Technical Note

Highways Review

Project	Land to the East of Lynsted Lane, Teynham	Job No	1000007836
Subject	Highways Review – Technical Note	Issue	02
Prepared by	Olivia Reed	Date	12/04/22
Approved by	Ben Meekings	Date	12/04/22

Figure 1: Revised Layout on Lynsted Lane

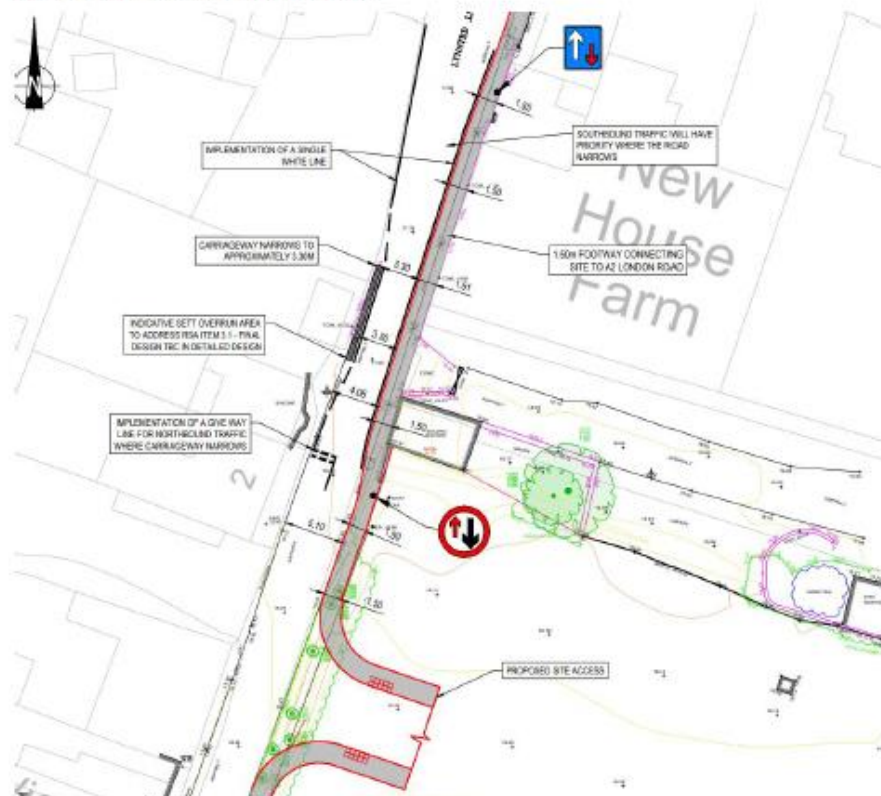
- 2.9 There has been no update to the outline TS report discussing the proposed changes to Lynsted Lane (shown in Figure 1), which involves a priority give way control just north of the proposed site access.
- 2.9 The visibility splay plans should be updated with the required visibility splays in relation to the revised layout. This should demonstrate sufficient safe stopping sight distance (SSD) can be achieved on approach to the give way control.

- 2.21 We have no comments on the proposed pedestrian crossing points and footpath widening on Lynsted Lane, as agreed with KCC.
- 2.22 As mentioned above, visibility plans should be updated demonstrating that sufficient SSD can be achieved on approach to the proposed give way control.
